[Docket No. NHTSA–2009–0002]

Anthropomorphic Test Devices; SID–IIs Side Impact Crash Test Dummy; 5th Percentile Adult Female

ACTION: Final rule, response to petitions for reconsideration, technical amendment.

Figure 1: Alignment of iliac wing, backer plate, and load cell/replacement¹⁶

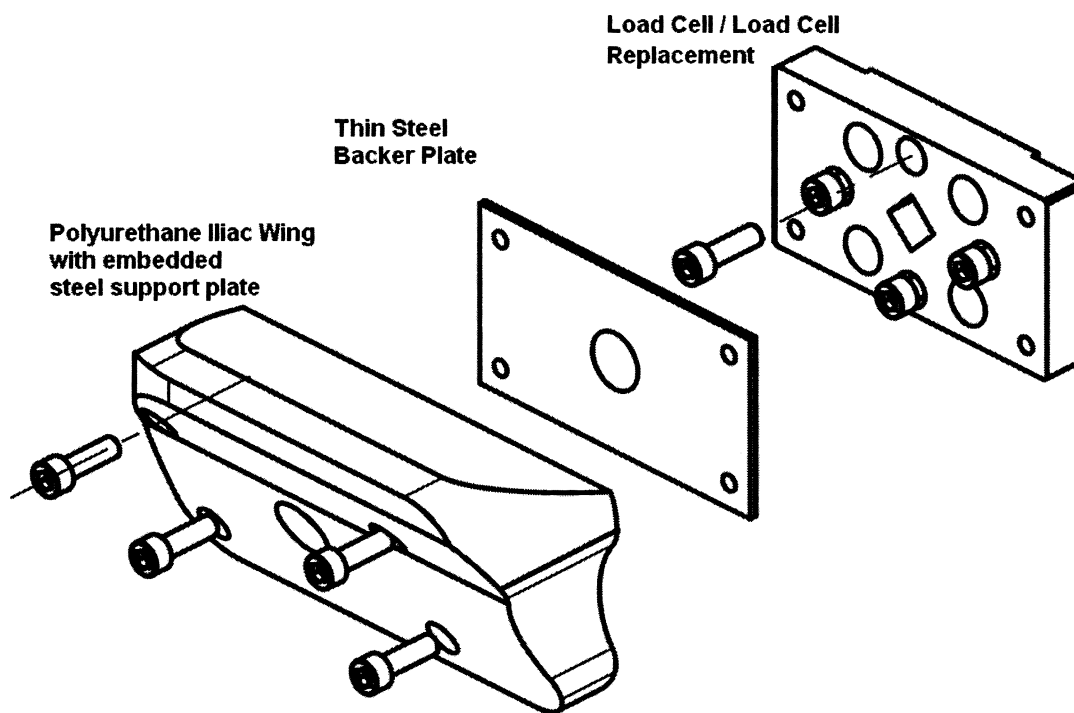
propensity to cause a load path short due to its design. According to FTSS, the original iliac wing design resulted in $\frac{1}{8}$ -inch polyurethane material being sandwiched between the embedded iliac wing support plate and the iliac load cell. It found that the amount of loading force the iliac is able to accurately measure can vary depending upon how much torque the iliac mounting screws are under, how much the polyurethane material creeps over time, and how much the iliac maintains its original shape.

FTSS stated that it has designed a new iliac substructure (support plate) that has a positive bearing surface contact between the iliac wing and the load cell to create a rigid mounting surface between the iliac wing and load cell.¹⁷ Essentially, the $\frac{1}{8}$ -inch thick polyurethane material around the mounting screw holes was replaced with $\frac{1}{8}$ -inch thick steel “standoffs” that extend from the embedded plate to the edge of the wing so that the mounting screws would draw the iliac wing to the load cell through a metal contact instead of through polyurethane. According to FTSS, this design eliminated the

potential for load path shorting since standard fastener torque values can now be specified for the iliac wing mounting hardware without losing the torque over time, and it also eliminated the material creep found in the original iliac design. FTSS recommended that NHTSA evaluate this new design and include it in the drawing package in place of the original.

artificially low measurements.” It stated, however, that while the use of the thin steel backer plate specified in the final rule (as shown in Figure 1) will reduce the likelihood of off-loading the load cell, it will not reduce deformation of the polyurethane iliac wing. It suggested that a more robust solution would be to use a rigid steel plate with standoffs that are embedded in the polyurethane iliac wing during manufacturing. The Alliance stated that “this stronger plate with standoffs eliminates the possibility of off-axis loading.”

plate between the wing and load cell, as specified by the final rule (Table 2). VRTC found that qualification test results from these two iliac configurations were very similar. The average response from wings without a backer plate was always lower than that from wings with a backer plate as seen in Table 2, but was also always less than a 2.5% reduction from the response with a plate.²⁰ Thus, the influence of the backer plate appears to be negligible. However, the plate can act to prevent load path shorting through wing contact with the center of the load cell. Although there were no instances of load path shorting during qualification tests without a plate, two quasi-static tests without a backer plate were conducted on both the softest and stiffest M3 iliac wings with standoffs. In this set of tests, the softest iliac wing made contact with the center of the load cell at a load of about 3,700 N (831.8 lb). To prevent this from happening, we have decided to retain use of the thin steel backer plate between the iliac wing and iliac load cell.

Figure 2: Examples of pelvis-acetabulum, pelvis Y acceleration response traces

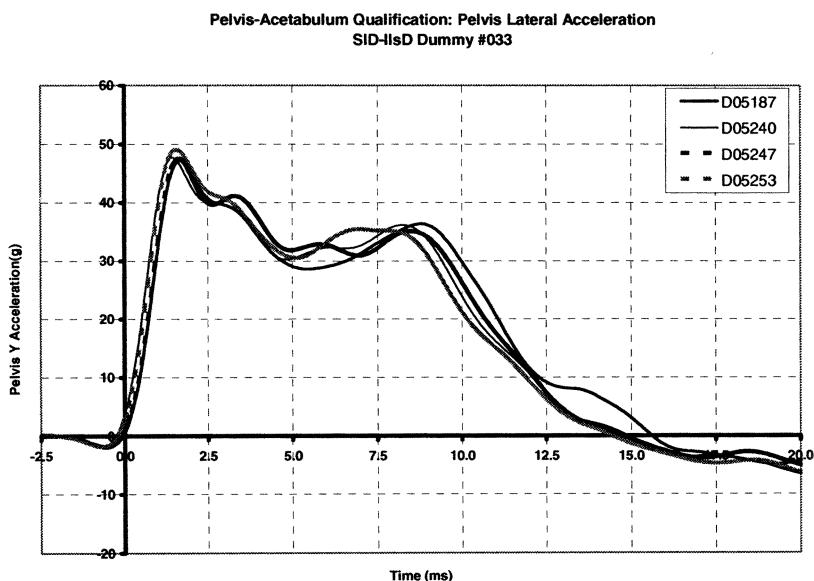
section, the first peak of the pelvis lateral acceleration response, which occurs in the first 5–6 ms, is based primarily on the plug response. Since the pelvis-acetabulum test aims to verify the pelvis response, not the plug response, the acceleration during the first 5–6 ms should not be included. However, NHTSA examined pelvis lateral acceleration traces in 11 side impact crash tests conducted with the SID-IIs Build Level D dummy to determine if the first peak, which results from initial pelvis plug crush in qualification tests, was part of the dummy response in vehicle tests. (If the first peak were part of the dummy response, we would be disinclined to disregard this peak in dummy qualification.) Crash test results showed generally unimodal pelvis Y accelerations, indicating that in vehicle tests, the initial plug crush does not play a significant role in the results.

To determine after what point in time the peak lateral pelvis acceleration should be taken, NHTSA analyzed pelvis lateral acceleration traces for 46 pelvis-acetabulum qualification tests from four dummies and two labs. The data clearly showed multiple, distinct peaks as seen in Figure 2. As mentioned previously, the first main peak and second small “bump” in the data are due to the pendulum impacting the pelvis plug and (most likely) the pelvis flesh, respectively. The second major peak (called the “second peak” henceforth) represents the response of the dummy after the leg mass comes into play, and is the measure of interest for qualification of the dummy. As the petitioners claimed, the first peak was consistently higher than the second peak. In order to prevent measuring this first, less meaningful peak for qualification, the petitioners recommended that the peak pelvis acceleration value be taken after 5 ms after probe contact with the dummy.

two tests, the peak of the main dummy response occurred just before 6 ms (see Figure 4), causing the peak after 6 ms to be slightly less than the actual peak. This occurrence was rare, though, and only resulted in an error of approximately 0.1 g for both tests. As a result of this evaluation, this final rule specifies that the peak pelvis lateral acceleration be taken after 6 ms.

Figure 3: Pelvis Y acceleration traces (with the exception of D05149) with main response peak values lower than the acceleration at 5 ms

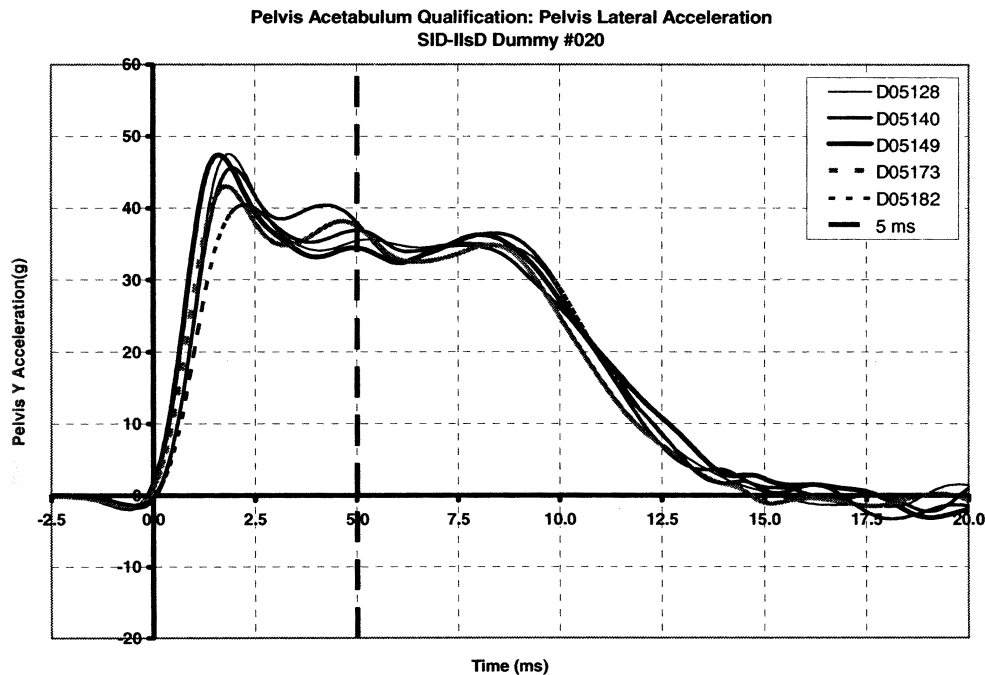
It was not clear from the data that 5 ms was the most appropriate time to begin measuring a peak value. For each of these 46 traces, the peak values after 5 ms, 6 ms and 7 ms were obtained in order to determine how much time after probe impact should be disregarded to prevent the first peak from being measured. It was found that in five of the 46 tests, the maximum value after 5 ms was higher than that after 6 or 7 ms, because the value of the decreasing “first peak” response at 5 ms was higher than the main dummy response peak value. Four of these 5 instances occurred in Dummy S/N 20, and are seen in Figure 3 below. These cases led the agency to determine that the peak should be taken after 6 ms. However, in

Figure 5: Peak shoulder deflections generated at probe impact velocities of 4.2 – 4.5 m/s

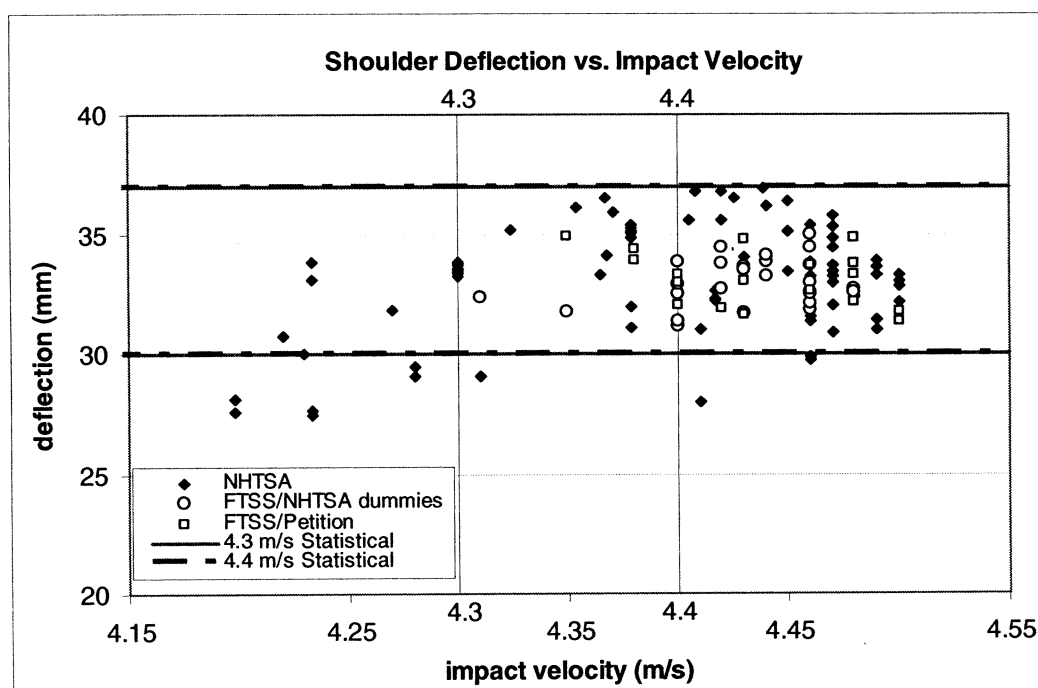
Figure 5 shows the peak shoulder deflection responses with respect to the impact speed of the pendulum. It is observed that the peak deflections are noticeably lower at impact speeds of approximately 4.2 m/s. Because of this observation, the qualification performance corridors have been formed with the mindset that the statistical corridor (which is centered at the mean

of the data set) may have to be adjusted to accommodate low deflections at the low impact velocities, since the mean of the 4.2–4.4 m/s data set may be slightly high due to the majority of tests being conducted between 4.3–4.4 m/s. The revised corridors are discussed in “Analysis and Development of SID–IIISD Qualification Specifications in Response to Petitions for Reconsideration (July 1,

2008),”³¹ and in section XI.a of this preamble. We believe that by adjusting the performance corridor to reflect deflection responses at lower impact velocities, the new performance corridor will satisfactorily represent dummy responses over the full range of the revised specified impact velocities.

**FIGURE V4-A
SHOULDER IMPACT**

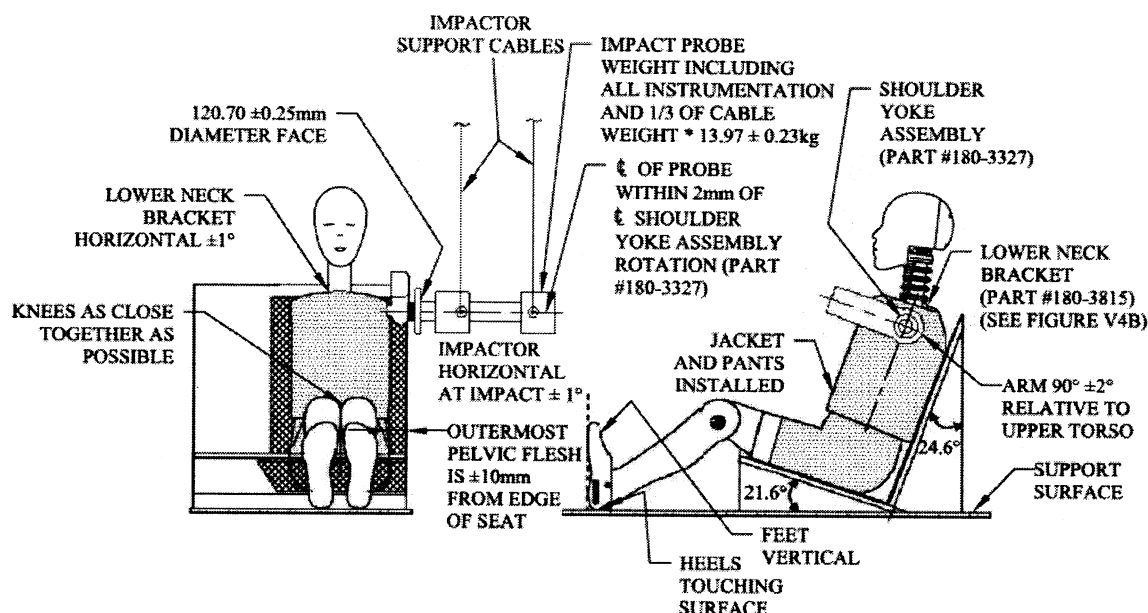
■ 13. Figures V4–A, V9–A and V9–B in “Appendix A to Subpart V of Part 572—Figures” are revised to read as follows:

* 1/3 OF CABLE WEIGHT NOT TO EXCEED 5% OF THE TOTAL IMPACTOR PROBE WEIGHT

**FIGURE V9-A
ILIAC IMPACT**

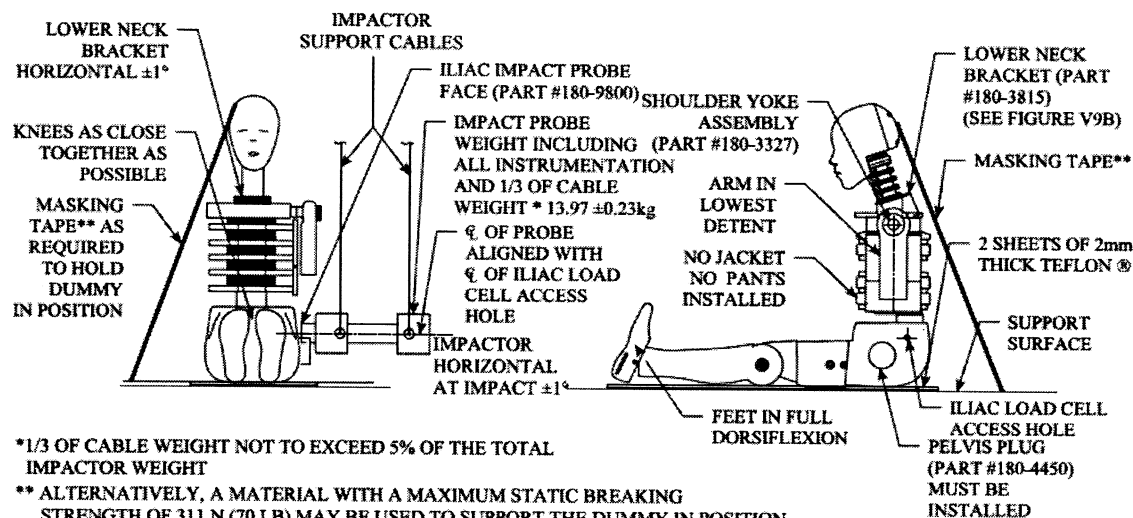
(5) The midsagittal plane of the dummy is vertical, and superior surface of the lower half neck assembly load cell replacement (180–3815) in the lateral direction is within ± 1 degree relative to the horizontal as shown in Figure V9–A.

*1/3 OF CABLE WEIGHT NOT TO EXCEED 5% OF THE TOTAL IMPACTOR WEIGHT

** ALTERNATIVELY, A MATERIAL WITH A MAXIMUM STATIC BREAKING STRENGTH OF 311 N (70 LB) MAY BE USED TO SUPPORT THE DUMMY IN POSITION

**FIGURE V9-B
ILIAC IMPACT
(NON-IMPACT SIDE VIEW)**

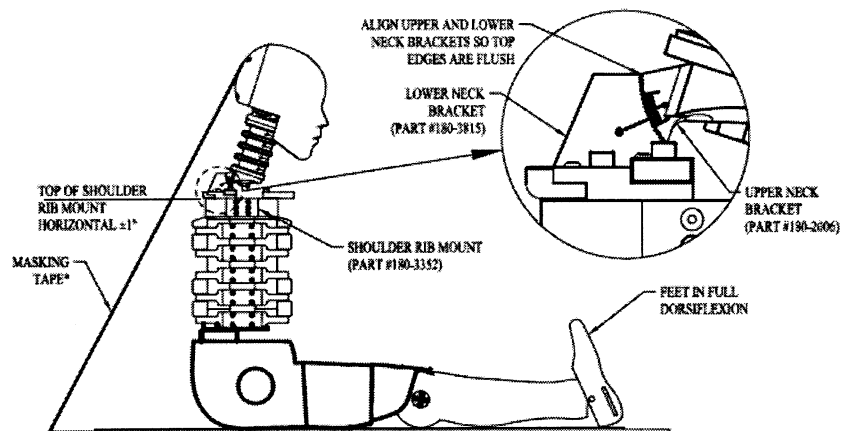
(6) While maintaining the dummy's position as specified in paragraphs (b)(3), (4) and (5) of this section, the top of the shoulder rib mount (180–3352) orientation in the fore-and-aft direction is within ± 1.0 degree relative to horizontal as shown in Figure V9–B in Appendix A to this subpart.

* ALTERNATIVELY, A MATERIAL WITH A MAXIMUM STATIC BREAKING STRENGTH OF 311 N (70 LB) MAY BE USED TO SUPPORT THE DUMMY IN POSITION
